Proposed residential development on Land off Cambridge Road, Stretham, East Cambridgeshire.

Application Ref: 24/01135/OUM

- 1.1. This report has been prepared by Alison Farmer Associates on behalf of East Cambridgeshire District Council. Work has included the review of the Landscape and Visual Impact Assessment (LVIA) for planning application 24/01135/OUM for 126 dwellings west of the A10, Stretham.

Figure 1: East of England Typology

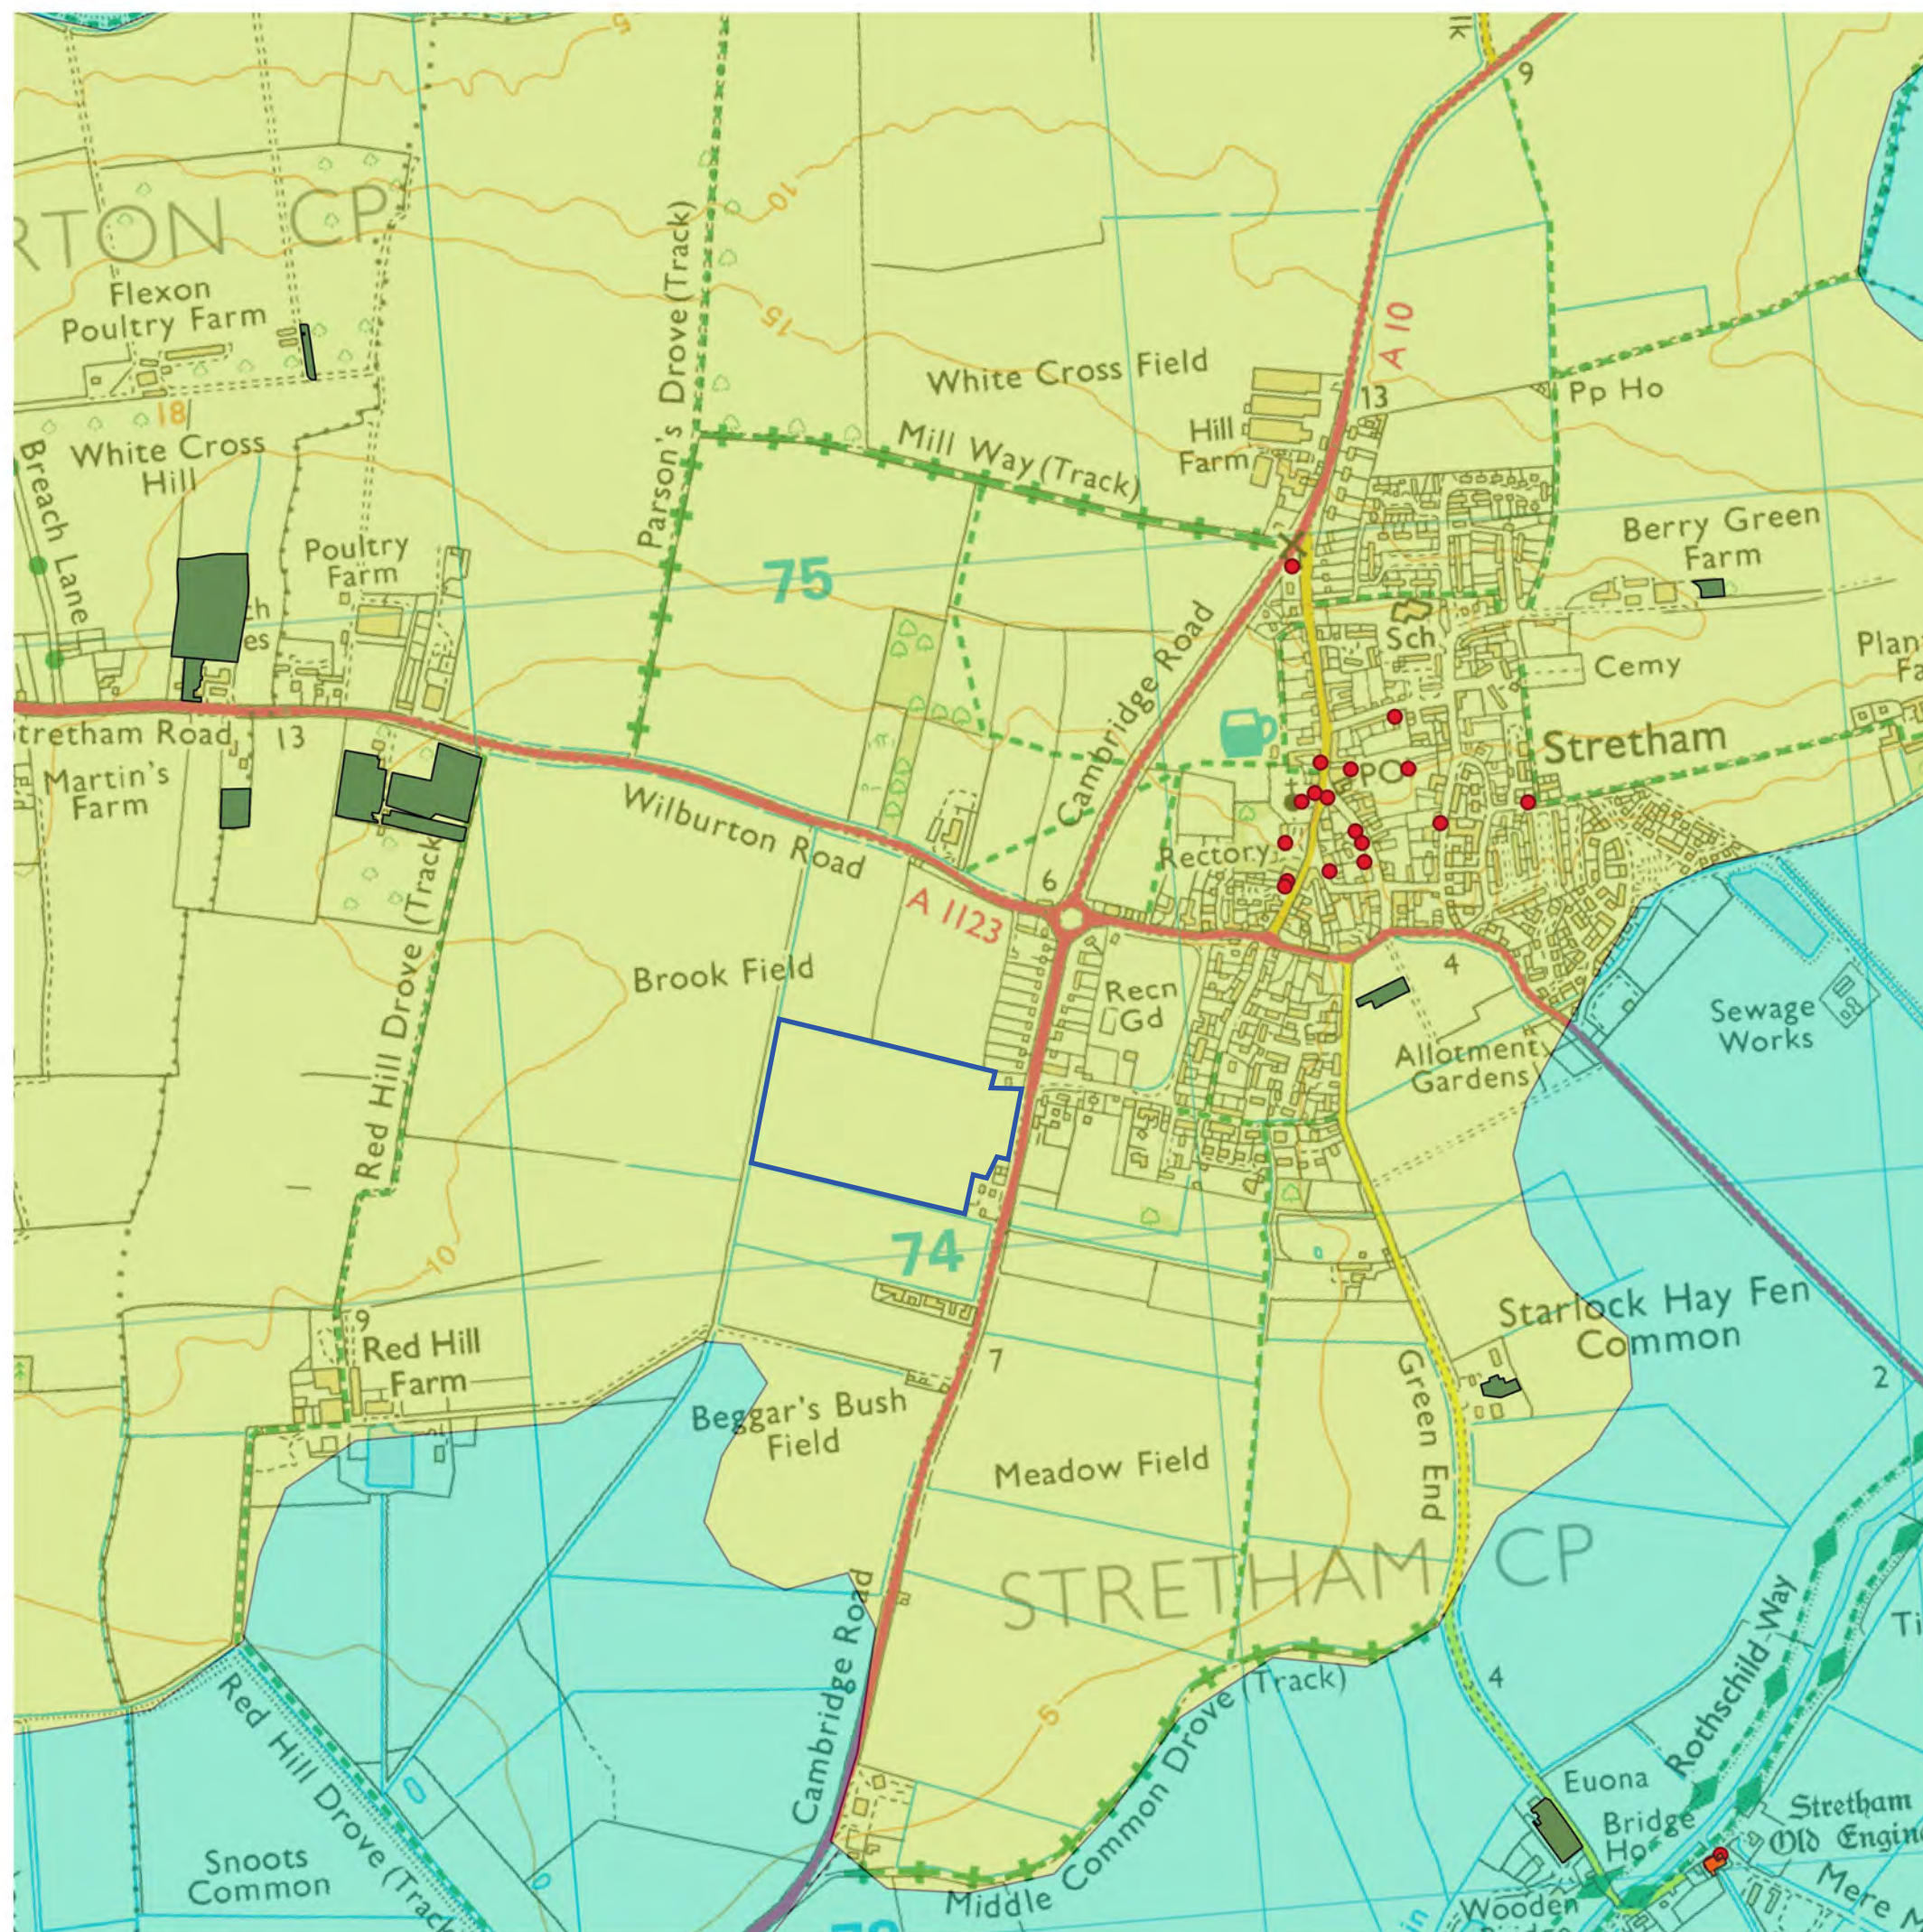
- 3.8 The **East of England Typology** whilst not accompanied by detailed descriptive material provides a finer grained understanding of local character distinguishing between the fens (Planned Fen) and settled islands (Lowland Village Farmlands) as illustrated on Figure 1 below.

- 3.9 The contours shown on Figure 1 also illustrate the lower lying and less distinct topography in the vicinity of the site when compared to the steeper slopes of the island on which the historic settlements of both Stretham and Willburton are located.
